A/NE-PK/234

Response to the Transport Department' s comments

LAYOUT PLAN

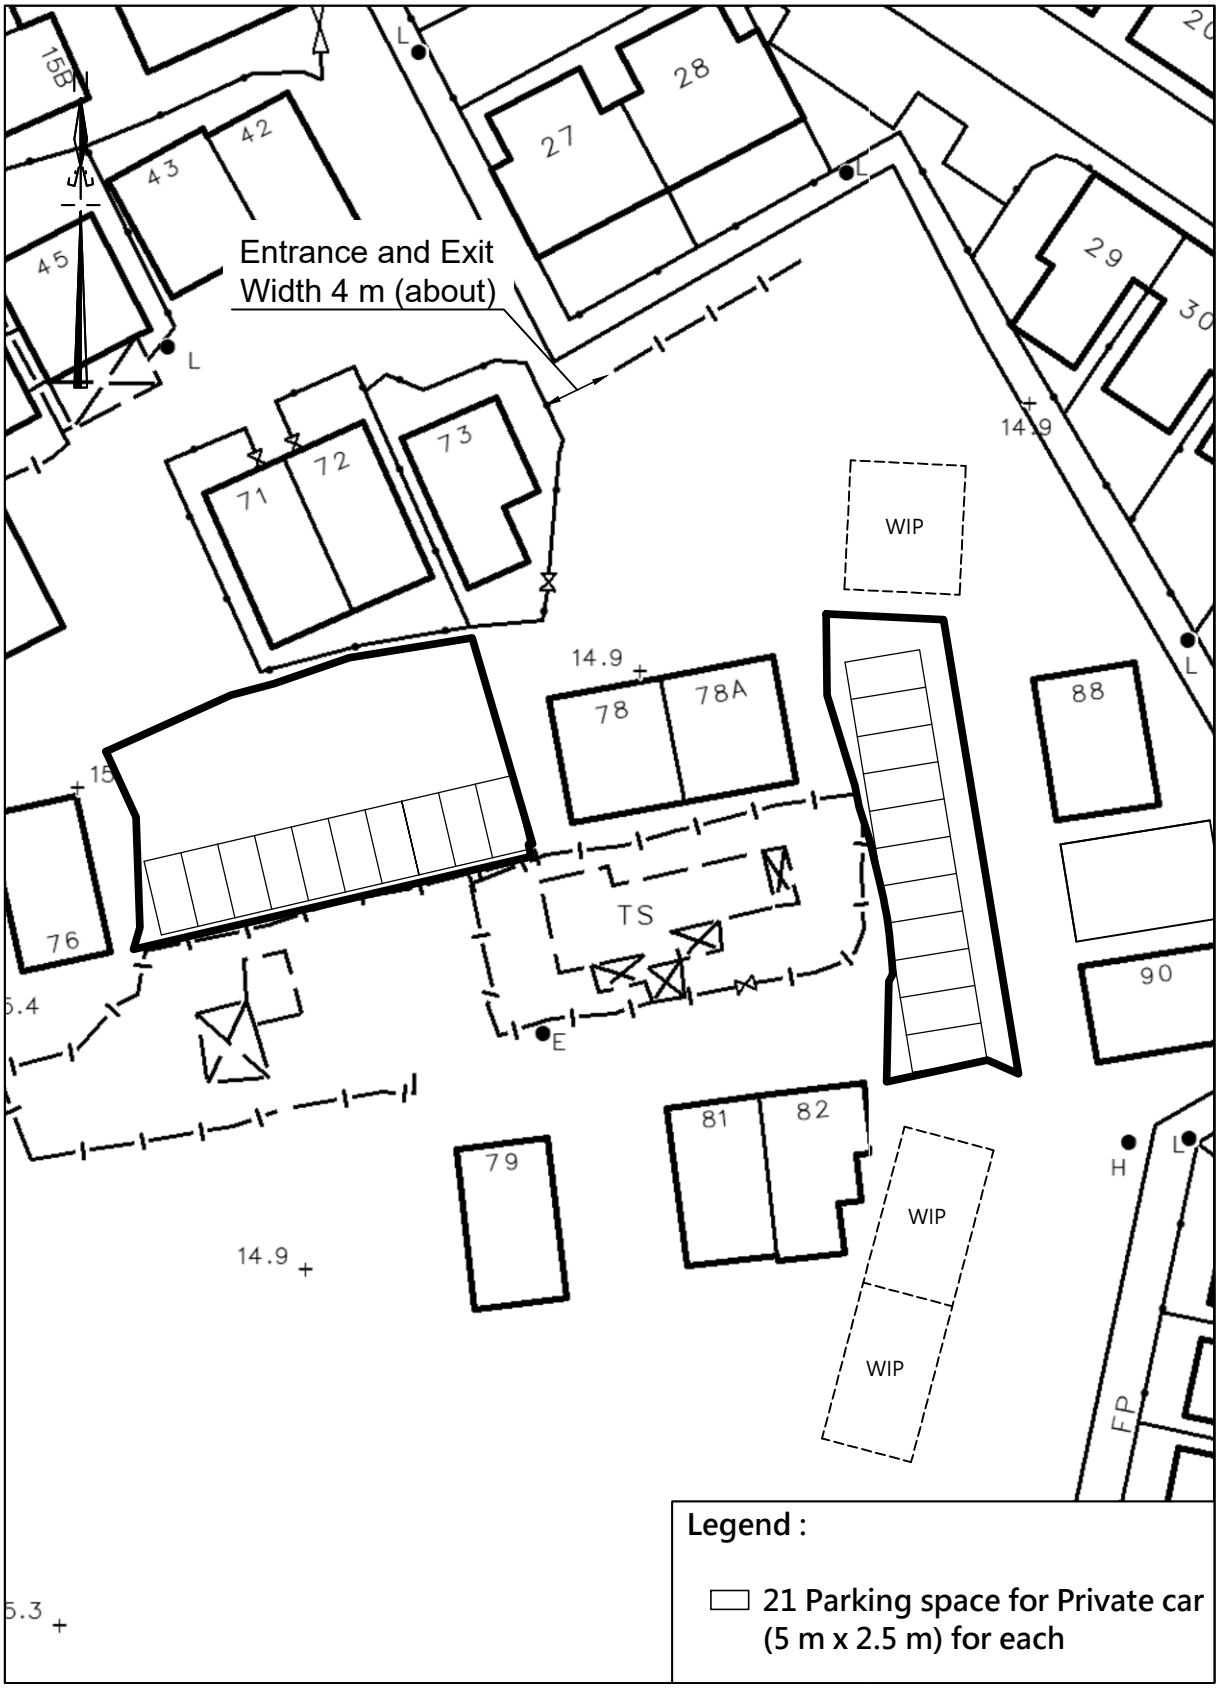
1. Please refer to the legend on the layout plan for the parking space dimensions.
2. The 5 meters wide section of road will be used as a buffer zone, and parking will be prohibited. A sign warning drivers to watch for oncoming traffic will be installed, along with speed humps to ensure that vehicles travel at a safe speed. The application site was previously used as a car park for private cars only, and no clash accidents have ever occurred there.

3. We will install sign boards at the road bends to remind road users to watch out for vehicles, and aconvex mirrors to help them see the road conditions clearly.

1. The parking spaces at the application site are currently unregulated. If approval is granted, all parking spaces will be laid out in accordance with the layout plan submitted with application
